CALIFORNIA COASTAL COMMISSION

W13c**STAFF REPORT: REGULAR CALENDAR****APPLICATION NUMBER:** 5-00-034**APPLICANT:** Mike McKinley and John Bass**AGENT:** Alan Block**PROJECT LOCATION:** 327 and 327 1/2 Paseo de Cristobal, City of San Clemente, Orange County

PROJECT DESCRIPTION: To permanently authorize the construction allowed under Emergency Permit 5-98-273-G for a new 110 foot long by twenty foot tall retaining wall with sixteen caissons on a coastal bluff and backfilling the area between the retaining wall and the landslide scarp with approximately 1600 cubic yards of material on two lots totaling 26,481 square feet. Re-landscaping the bluff below the retaining wall with native vegetation and the construction of new backyard hardscape on both lots.

EXHIBIT No. 4
Application Number: 5-00-034
Proposed Wall
California Coastal Commission

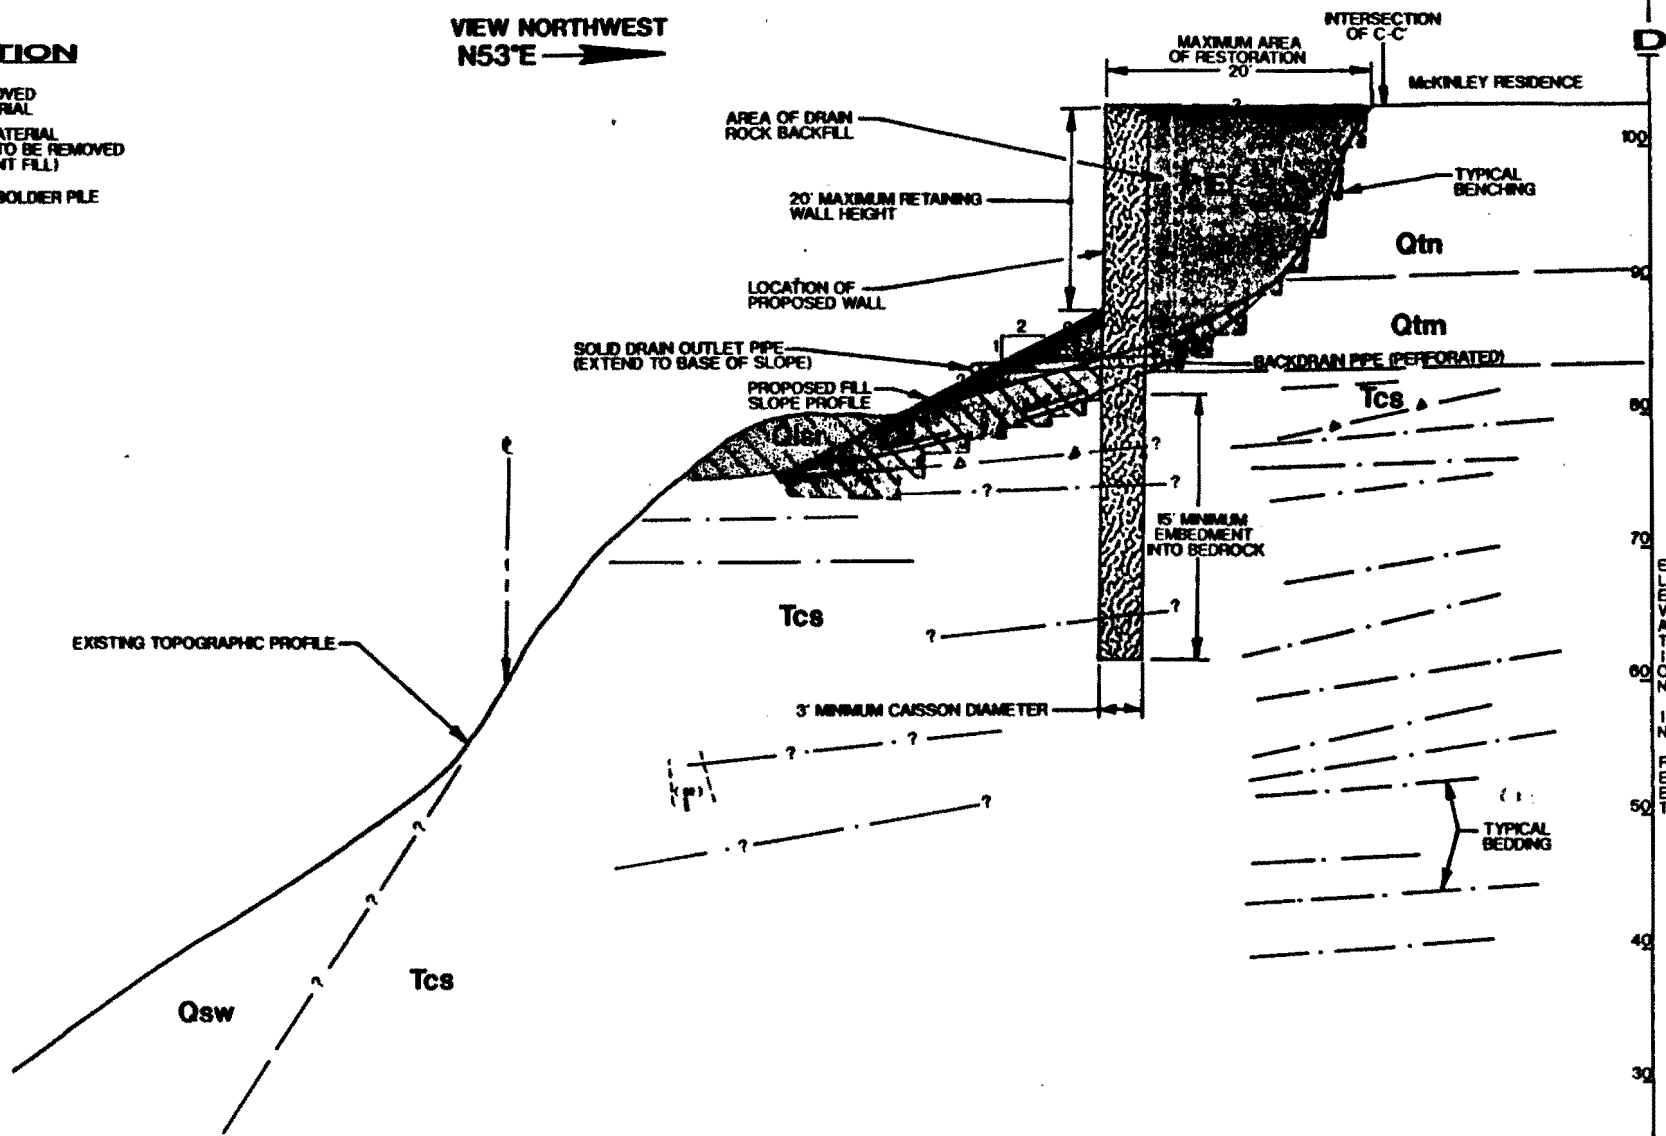
In terms of the use of vegetation to screen the wall, the height of the wall (20 feet) limits the ability to screen the wall through vegetative means. The applicants have submitted a list of plants (Exhibit 18) which can potentially screen the wall. These plants include *Myrica californica*, *Prunus ilicifolia*, and *Rhus integrifolia*. Though these plants may eventually screen the wall, it may take approximately ten years for the plants to grow to height which will screen the wall.

Because of the retaining wall's height and length, the Commission finds that all three treatment styles are necessary to minimize the adverse visual effects of this manmade structure. For example, even though an attempt was made to colorize the wall to match the ground, it is nevertheless highly visible as a manmade structure due to the lack of vegetative screening and the lack of three dimensional texture to match the grain and shape of the bluff face. Therefore, the Commission is imposing a special condition to require that the applicant submit plans, for the review and approval of the Executive Director, for minimizing the visual impacts of the retaining wall through landscaping, colorization and texturization.

The applicants, through a letter from Harold Larson (October 5, 1999, Exhibit 16), also contend that the colorizing and texturizing the wall plus the inclusion of planting pockets would weaken the wall and create a maintenance problem besides being expensive. A later letter from Mr. Larson (May 17, 2000) notes that the wall could support top planter boxes, with soil, not weighing more than 250 pounds per linear foot, which addresses the concern about weakening the wall. The Commission's Coastal Engineer has reviewed the assertion that the efforts to visually screen the wall would create maintenance problems (Exhibit 15) and

determined that maintaining the planters and wall veneer can be considered to be within the scope of normal maintenance. The Commission has required that many seawalls be fronted by a textured veneer and these seawalls are exposed to a much more hostile environment than this wall. The Commission concurs that maintenance of the wall, which benefits the applicants by protecting their property, is a normal activity that should be pursued to mitigate the project's adverse visual impacts on public views.

To help minimize the adverse visual impact, the applicants have proposed plants which will grow up to 20 feet in height (Exhibit 18). These plants include *Myrica californica* which will achieve a height of 15 to 20 feet in ten years, *Prunus ilicifolia* which will achieve a height of 20 to 25 feet in ten years and *Rhus integrifolia* which will achieve a height of 10 to 15 feet in ten years. At their full height, the plants will screen the wall. The applicants believe that colorizing and texturing of the wall is therefore unnecessary. Though the plants proposed by the applicants may eventually screen the wall, the Commission finds that colorizing and texturing in combination with the plantings is still necessary, as the plants will take an estimated ten years to screen the wall, during this interim period an adverse visual impact will remain which must be mitigated.

Furthermore, the applicants through construction of the retaining wall have immediately restored their backyards for their private benefit; however, mitigation for the adverse public visual impact of the retaining wall has not been fully proposed. The emergency permit granted to construct the retaining wall explicitly stated that the visual impacts of the retaining wall would be resolved through this permit action. Simply requiring the planting of vegetation will take years to successfully screen the wall since small plants must be planted as full sized plants do not survive transplanting very well. During this interim period, while the plants are growing, the wall will be highly visible. Therefore, to resolve the adverse public visual impact, the wall must be colorized and texturized.

- A. **PRIOR TO ISSUANCE OF THE COASTAL DEVELOPMENT PERMIT**, the applicant shall submit, for the review and approval of the Executive Director, final plans for the retaining wall. To minimize the visual impact of manmade structures on the natural bluff, the retaining wall shall blend in with the color and texture of the surrounding terrain. The retaining wall shall also be screened through the placement of plants at the base of the retaining wall which can grow to a height of at least twenty feet, the use of planting pockets on the face of the retaining wall, and the use of vegetation at the top of the retaining wall that can cascade down the face of the wall.

EXHIBIT No. 9
Application Number: 5-00-034
Landscaping Plan
 California Coastal Commission

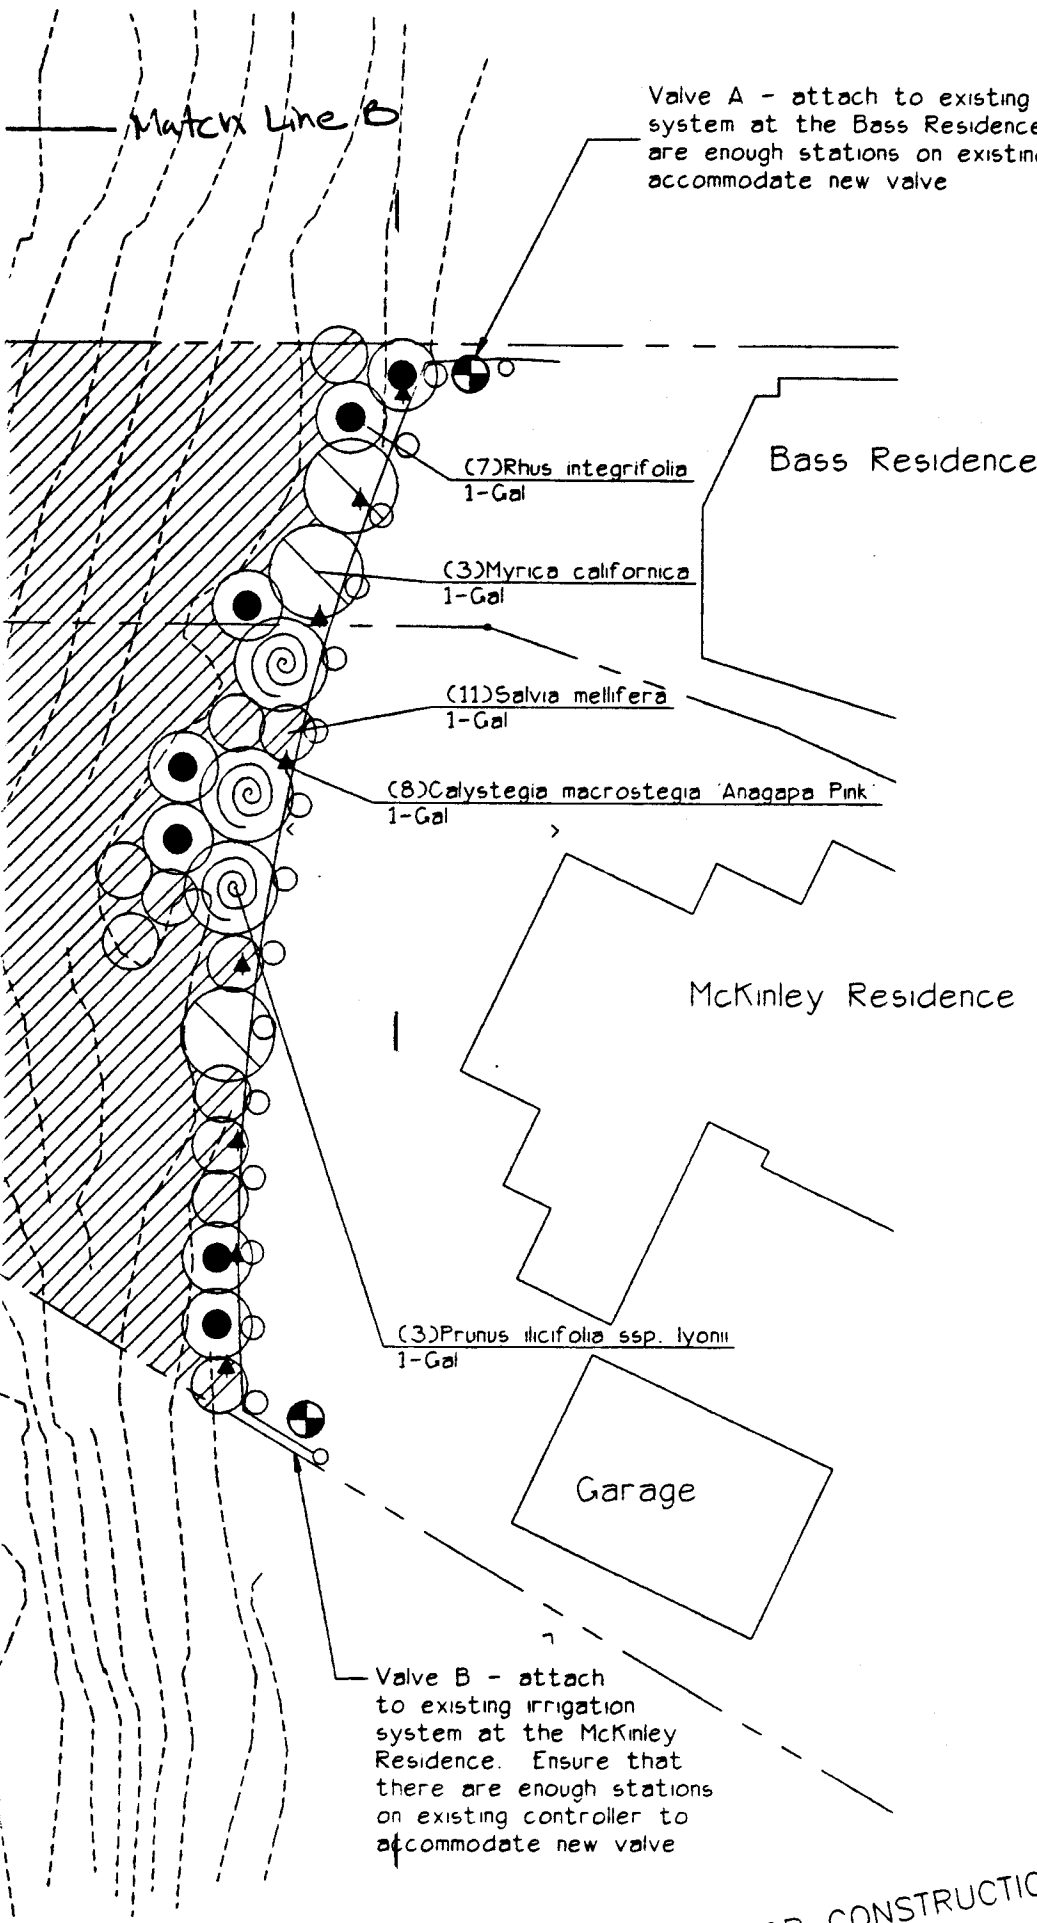
The Commission's coastal engineer (Exhibit 15) has reviewed the irrigation plan and found that it does not provide site-specific information nor will it provide any site specific feedback between evapotranspiration and irrigation water applied. While the Commission has approved irrigation plans for areas with an identified potential for landslides, such as at the Ocean Trails Golf Course and Pepperdine University, these plans have incorporated moisture sensors and feedback mechanisms that are continuously monitored by computer and insure that the irrigation volumes carefully match evapotranspiration rates and soil saturation. The only feedback mechanism proposed for this property is *"during periods of intense or prolonged rainfall, irrigation should be curtailed until the vegetation begins to show signs of distress."*

The Commission's coastal engineer concluded that the soil cap which is near the surface should prevent percolation of surface water into the backfill material. The current plan to provide general site irrigation of 32.6 inches annually could over-irrigate the site whenever the yearly rainfall exceeds 11.8 inches. In addition to potential saturation from irrigation, the backfill material would still be subject to potential saturation through the infiltration of groundwater traveling under the soil cap. While a detailed monitoring and irrigation plan may be beneficial in maintaining the long-term integrity of the soil cap, the proposed plan neither demonstrates that it can provide these benefits, nor demonstrates that it will not, during times of high rainfall, result in greater infiltration of the backfill material.

A. **PRIOR TO ISSUANCE OF THE COASTAL DEVELOPMENT PERMIT**, the applicants shall submit, for the review and written approval of the Executive Director, a landscaping plan to minimize the visual impact of the retaining wall and to enhance the habitat values of the coastal bluff fronting 327 and 327½ Paseo de Cristobal. The plan shall be prepared by a licensed landscape architect.

- c. No permanent irrigation system shall be allowed within either property. Temporary above ground irrigation to allow the establishment of the plantings is allowed.
